MEMORANDUM

DATE: August 24, 2018

RE: Response to July 11, 2018 Peer Review Memo of GHD

RE: Regulated Activity Permit, Hiawatha Lane and Hiawatha Lane Extension;
Response to A. Mozian Questions

WATERSHED EVALUATION AREA

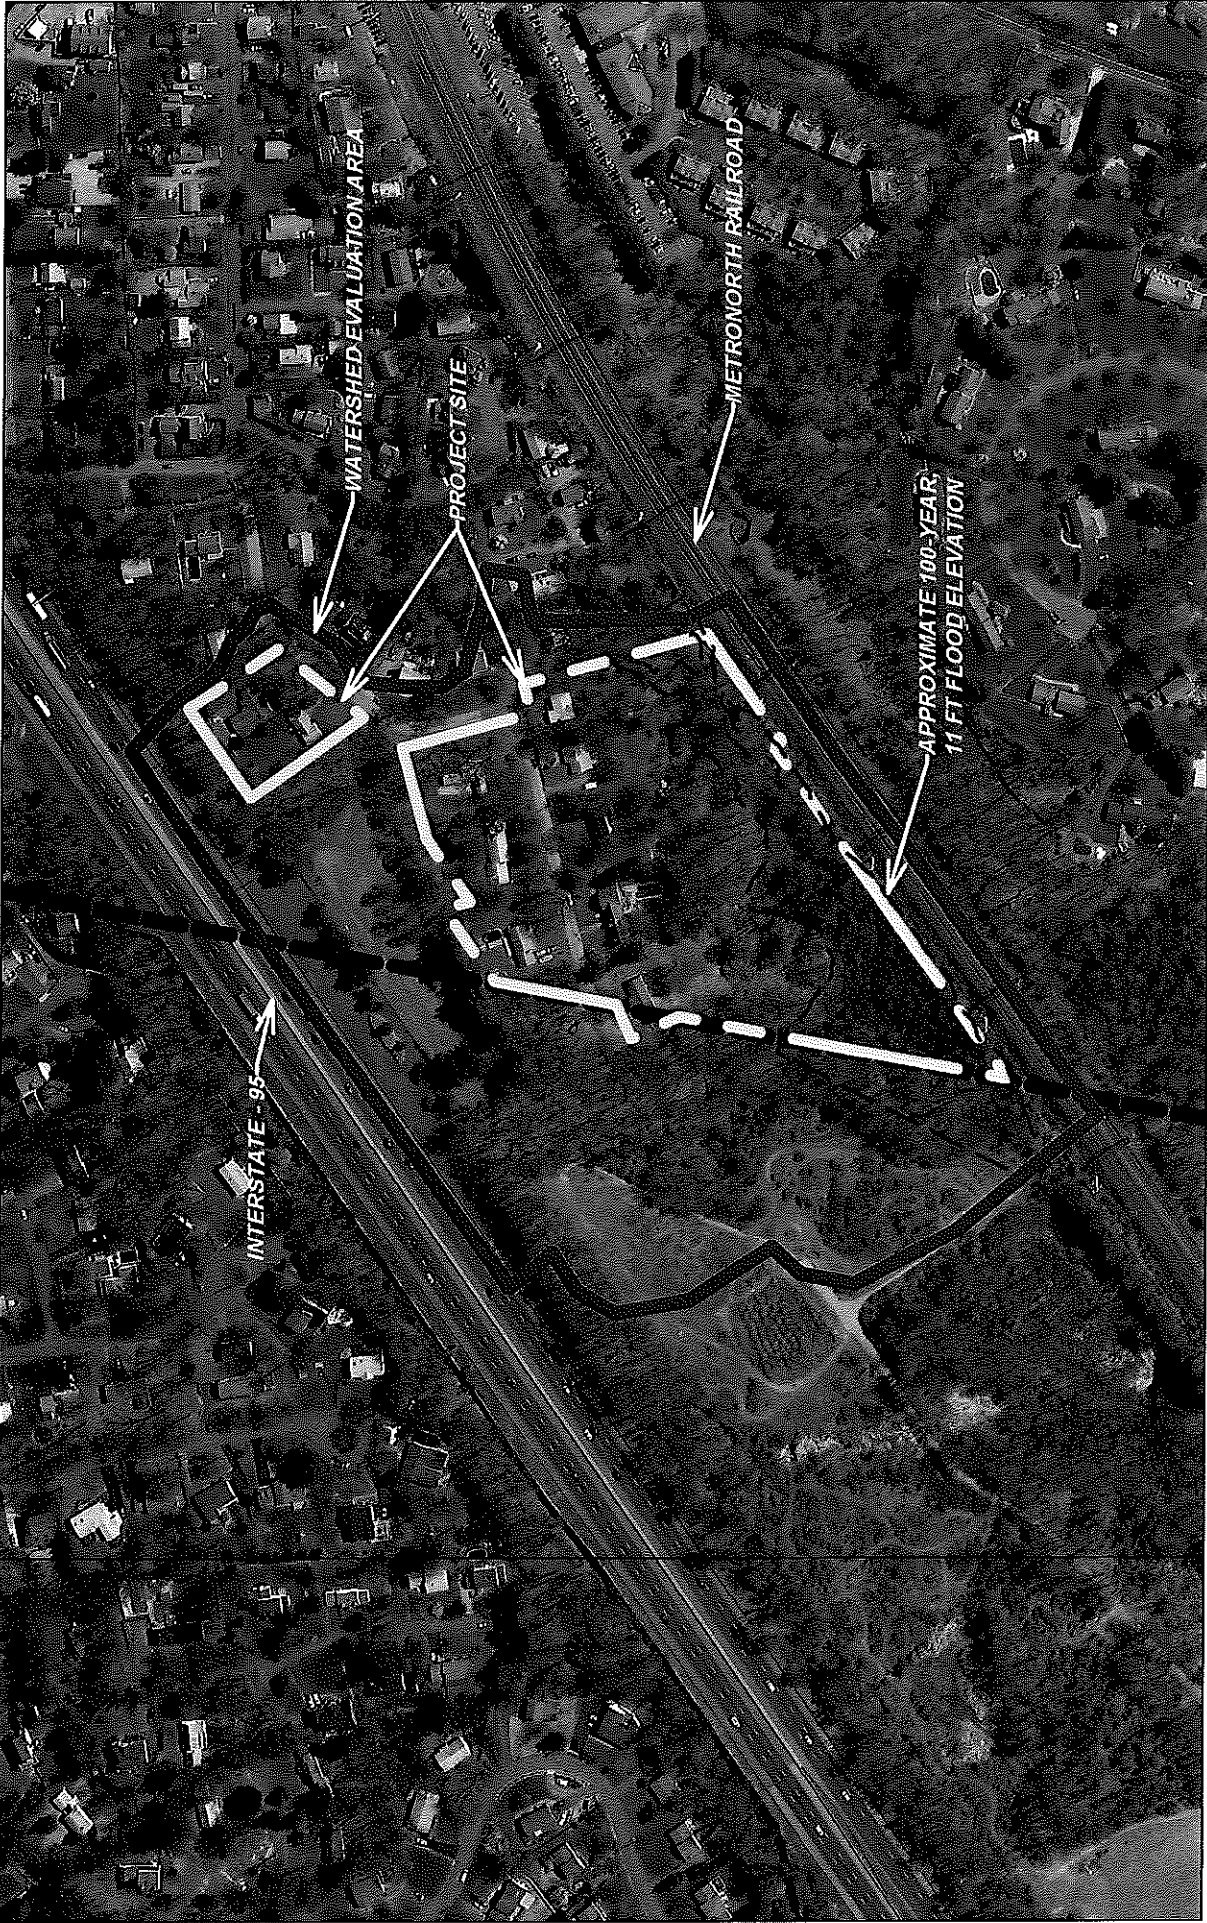
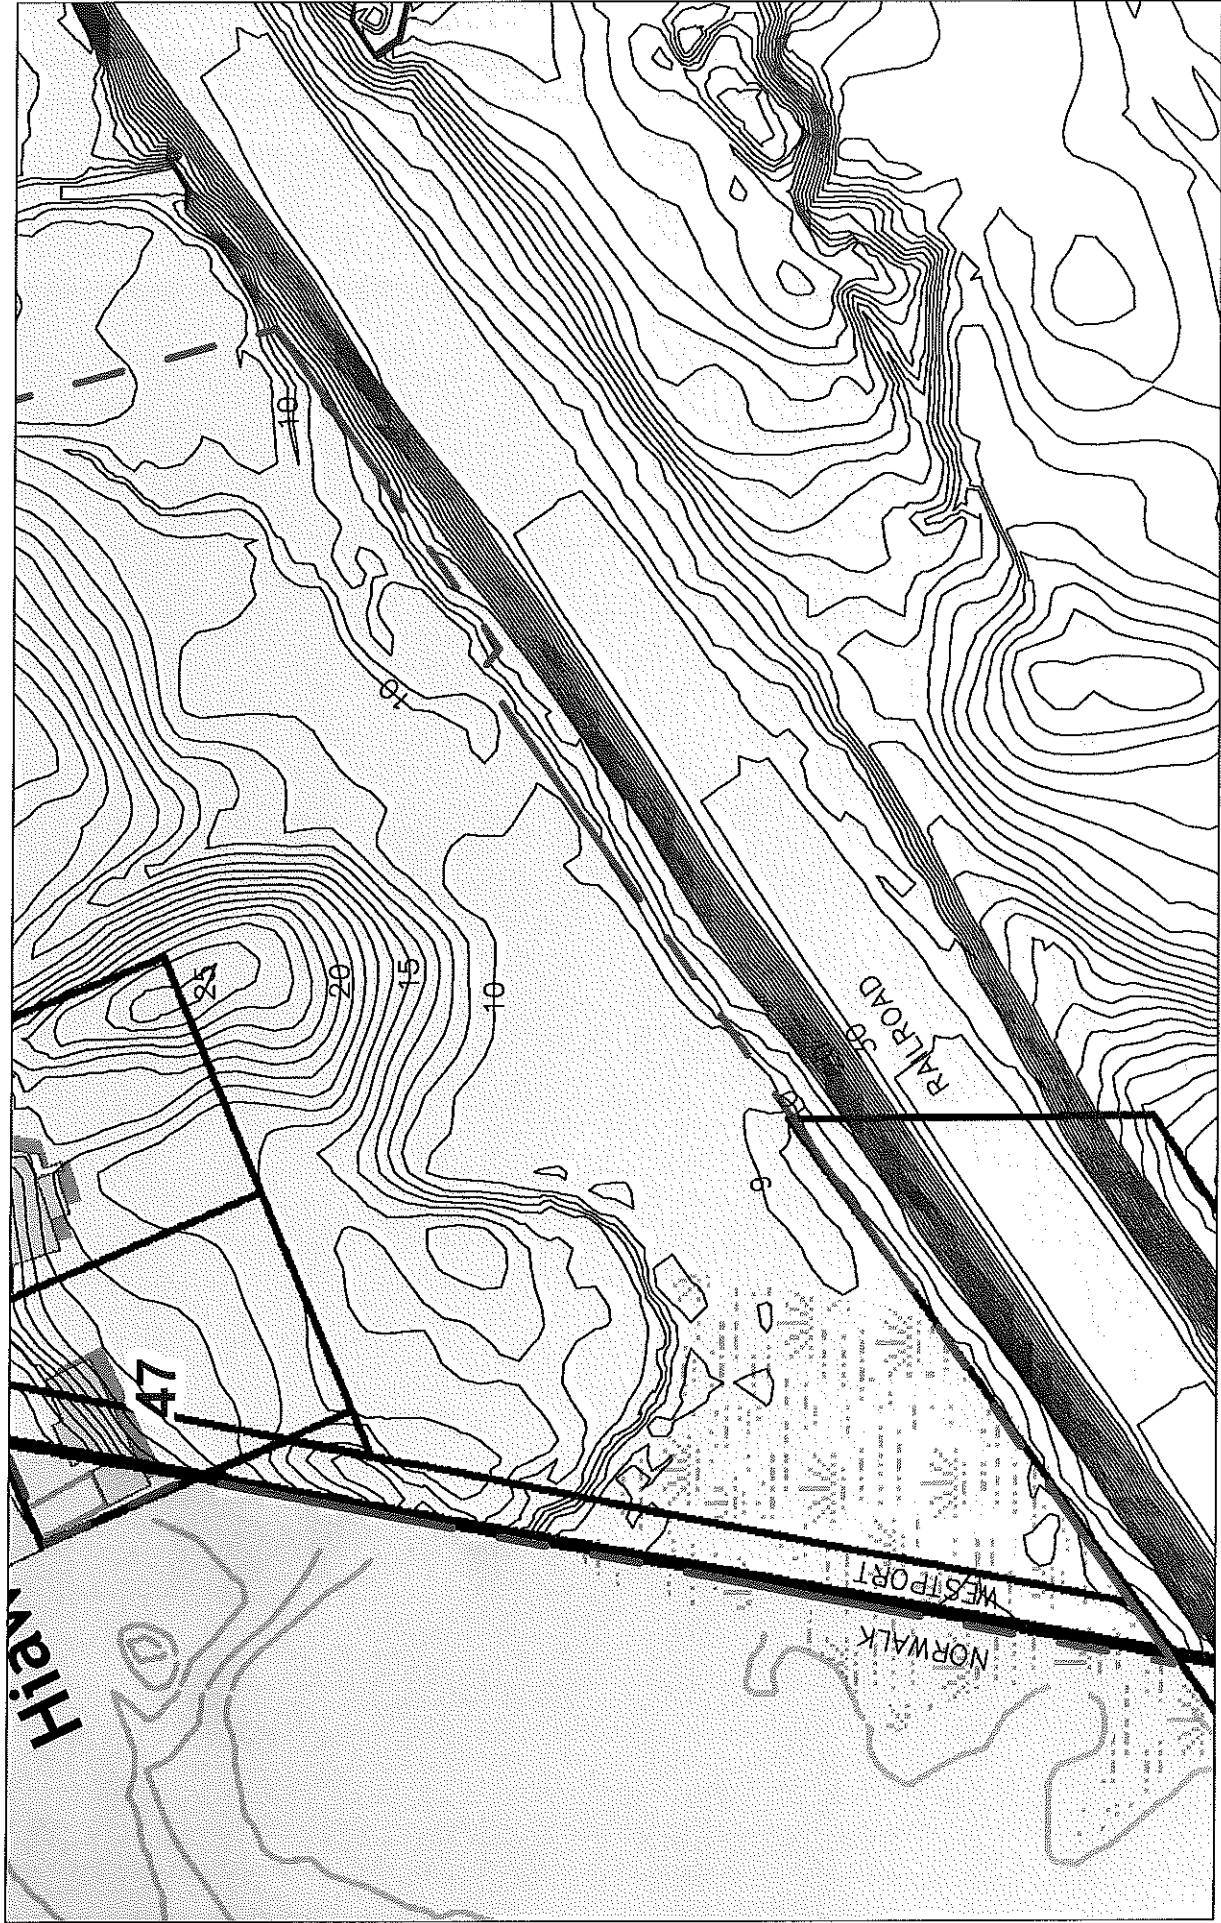
GHD recommends that the applicant show the topography of the wetland (2' GIS contours) and perform runoff calculations for the 100-year event to quantify the impact to the wetland water surface elevation as well as the potential risk of flooding down-stream properties.

<i>Item</i>	<i>Adequacy</i>	<i>Reason</i>	<i>Action Item</i>
<i>Proposed runoff calculations</i>	<i>Appear to be Inadequate</i>	<i>Does not include analysis for the 100-year storm, specifically related to offsite flooding and impact to water surface elevation of wetland</i>	<i>Show topography on plans to the south of the site (wetland) and summarize impacts of 100-year storm</i>

RESPONSE: A further evaluation of potential impacts on surface elevation within the wetland south of the proposed redevelopment has been completed. This evaluation includes GIS topography with 1-foot contours and a PondPack modeling summary of existing and proposed conditions for the wetland area. Due to the proposed use of detention measures including below ground infiltration systems and infiltration basins, the total runoff volume decreases from existing to proposed conditions. This evaluation found that the project will not increase the peak water elevation within the wetland area for storms up to and including the 100-year storm, and therefore the redevelopment will have no impacts on the flooding of downstream properties. The peak water elevation decreases by approximately three-quarters of an inch for the 100-year storm. *See Exhibit 1, Wetland Water Level Impact Evaluation for additional information.*

The south side of the site includes a wetland area adjacent to the MetroNorth Rail Road. The wetland extends along the railroad to the west and east beyond the project site. A culvert crosses under the railroad to drain the wetland. An evaluation of the watershed area tributary to the wetland was performed to evaluate the impact on the wetland area that is expected to occur as a result of the proposed project. See Figure No. W-1, Watershed Evaluation Area, for additional information

The results of the model show that the effect on the wetland flood elevation from the project will be minimal, with a slight decrease in the peak elevation expected.

EXHIBIT 2
SUMP PUMP CUT SHEETS

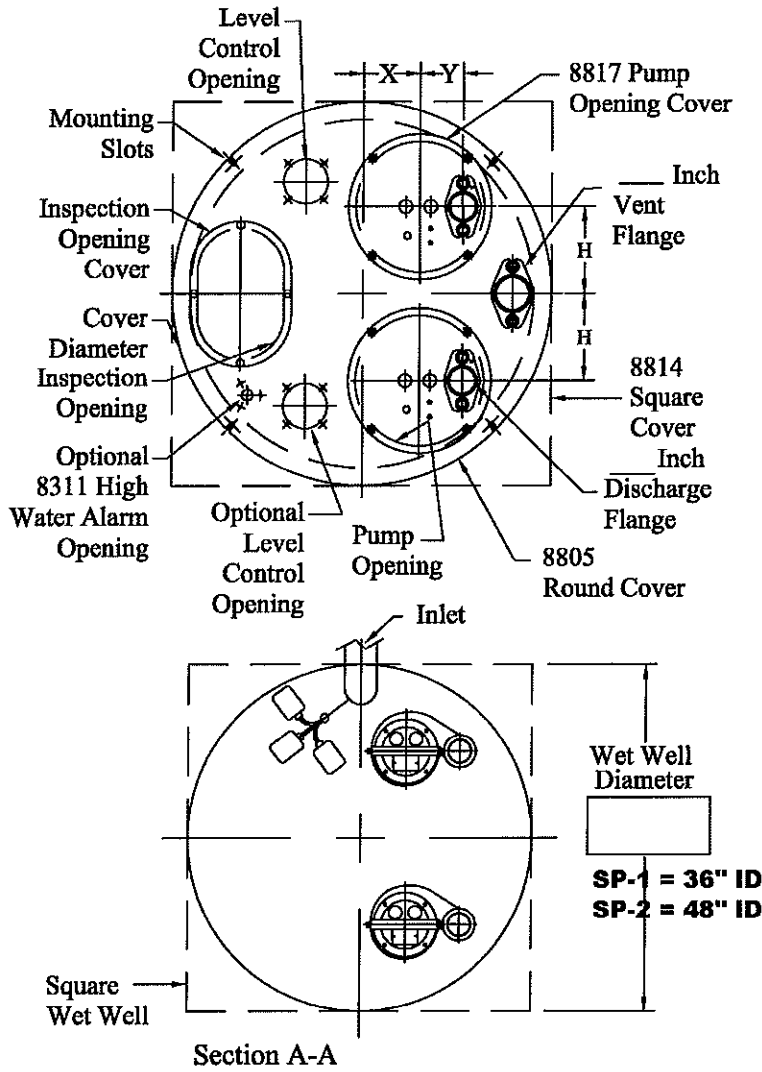
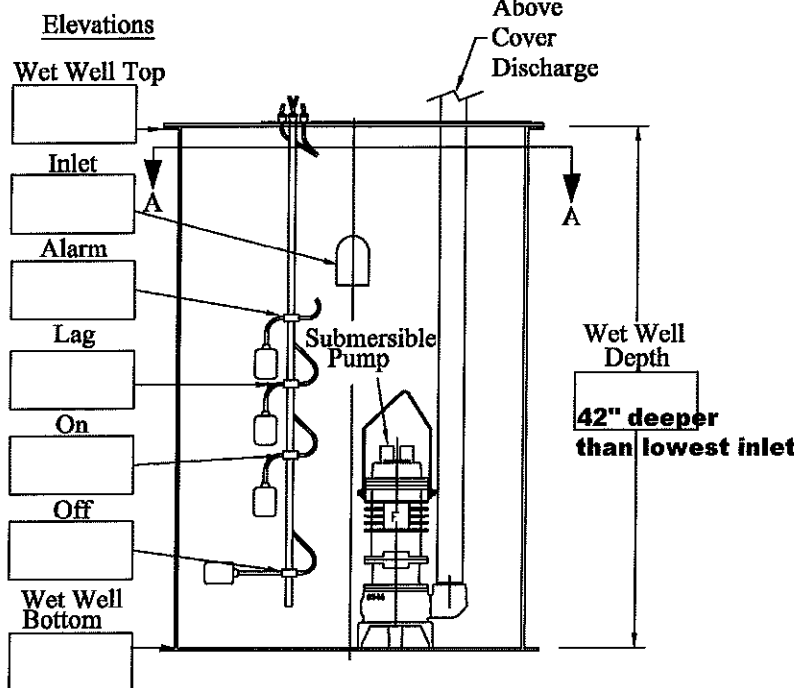
Sheet SP-2.2 also refers to a "building sump pump" in the garage of Building A; The application provides little to no information regarding the routing, discharge capacity, or discharge location. GHD recommends that the applicant submit detailed information on this pumping system.

<i>Item</i>	<i>Adequacy</i>	<i>Reason</i>	<i>Action Item</i>
<i>Sump Pumps</i>	<i>Appear to be inadequate</i>	<i>Sheet SP-2.2 refers to a building sump pump in the garage of Building A. Routing of the discharge is unknown.</i>	<ul style="list-style-type: none"> • <i>Applicant to provide information on all building sump pump discharge locations.</i> • <i>If discharges connected to Town-owned storm sewer, provide analysis on pipe capacity with actual pump flow rates</i>

RESPONSE: Exhibit 2 includes a sump pump detail and pump curves. The footing drain and sump pump for Building E will connect to a proposed catch basin on the project site, which will connect to an existing catch basin on Hiawatha Lane Extension. Hiawatha Lane Extension is a private street, which means town permission is not required for the connection. The 2-inch discharge pipe from the sump pump will connect to the proposed catch basin with a 12-inch diameter outlet pipe. The pump has a rating of 30 gpm, and the 12-inch pipe has a total capacity of 1,600 gpm, and an available capacity of 1,000 gpm during the 25-year storm. The flow from the sump pump and the remainder of the site is less than the pre-development flow and the existing flow and that currently enter the existing catch basin.
